Project: Spirit Mountain Chairlift – Bid Package 02: Electrical

Solicitation No.: 25-99554

ADDENDUM – Addendum 1

Date	06/20/2025
Project #	2025088
Project Name	Spirit Mountain Ski Lift Replacement
Project Location	Duluth, MN

Sheet Number:
 E0.1

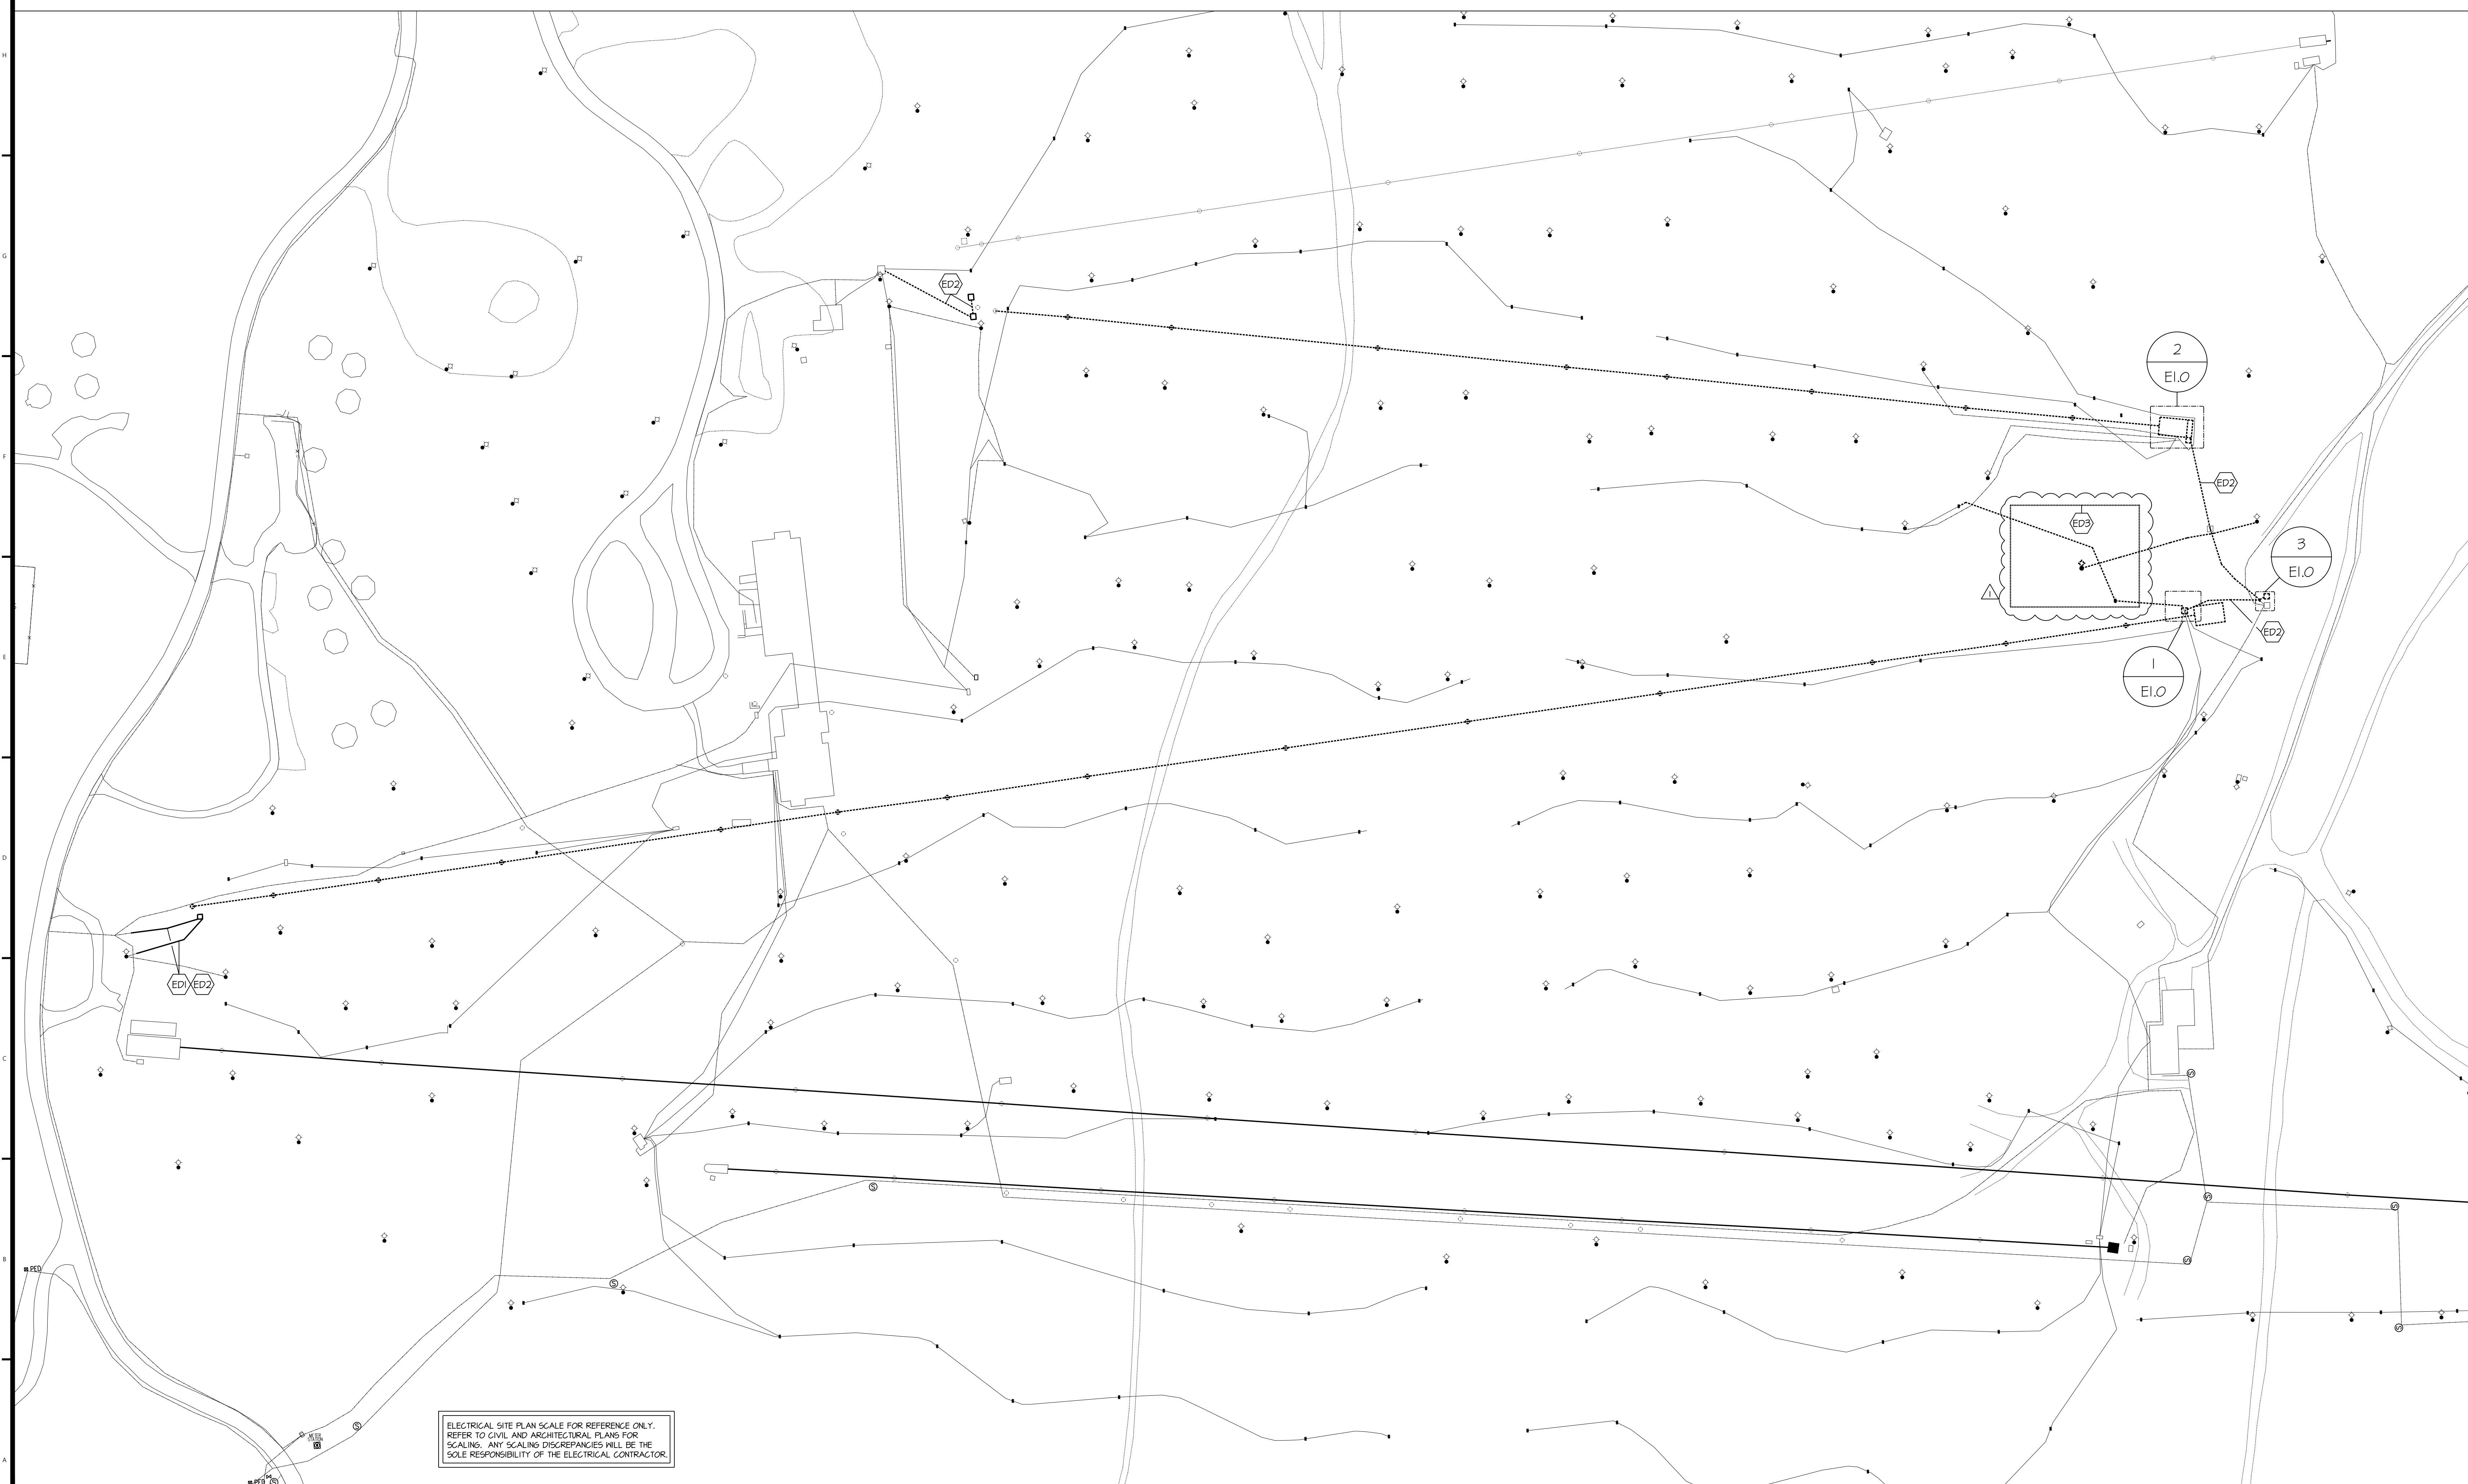
ITEM NO. 2 Sheet E0.1 – ELECTRICAL DEMO SITE PLAN

1. Modified sheet note ED2 to allow for abandoning disconnected conductors in place.
2. Indicated area on plan marked with dashed line and labeled with ED3 with planned owner landscaping that will add scope to new construction.

- ED1 DISCONNECT CONDUIT AND CONDUCTORS FROM KNIFE SWITCH ADJACENT TO TRANSFORMER PRIOR TO DEMOLITION OF CONNECTED STRUCTURE.
- ED2 DISCONNECT AND ABANDON CONDUCTORS AND CONDUIT IN PLACE.
- ED3 OWNER CONDUCTING LANDSCAPING IN THIS AREA. INDICATED DEMOLITION TO BE COMPLETED BY OWNER AND SHOWN FOR REFERENCE ONLY.

E0.2

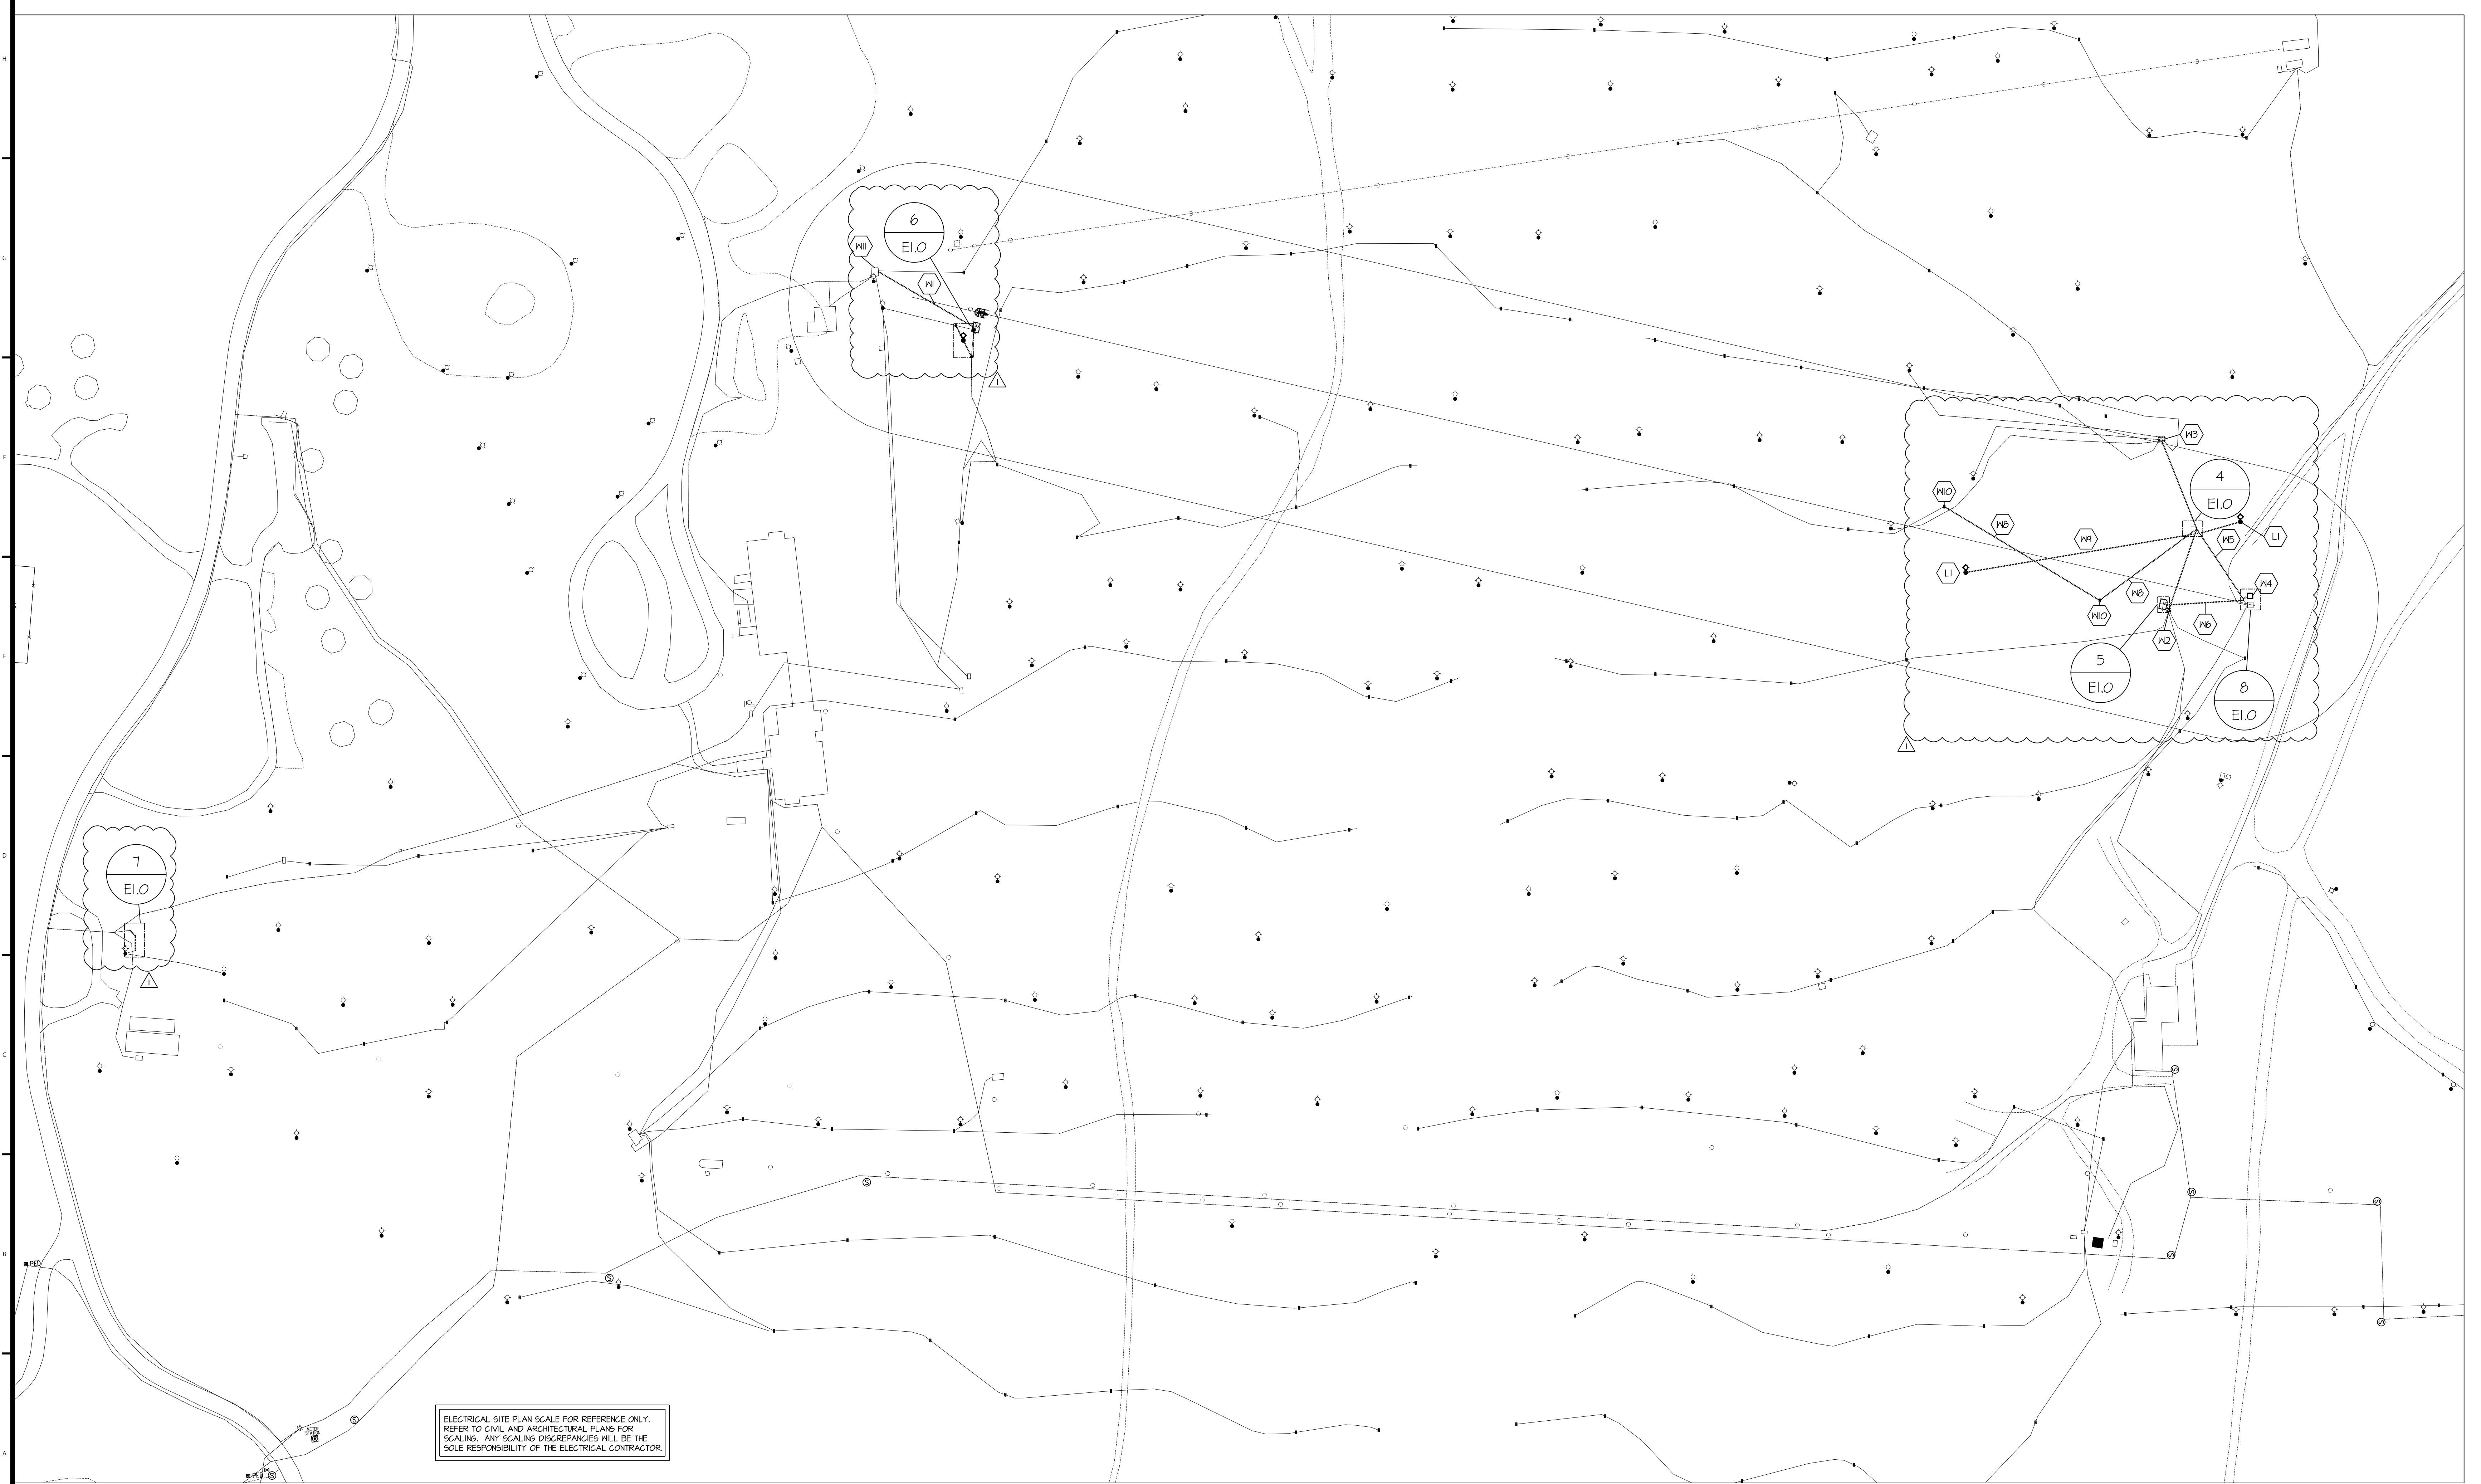
ITEM NO. 3 Sheet E0.2 – ELECTRICAL NEW WORK SITE PLAN

1. Significantly reworked scope on sheet, see drawing.
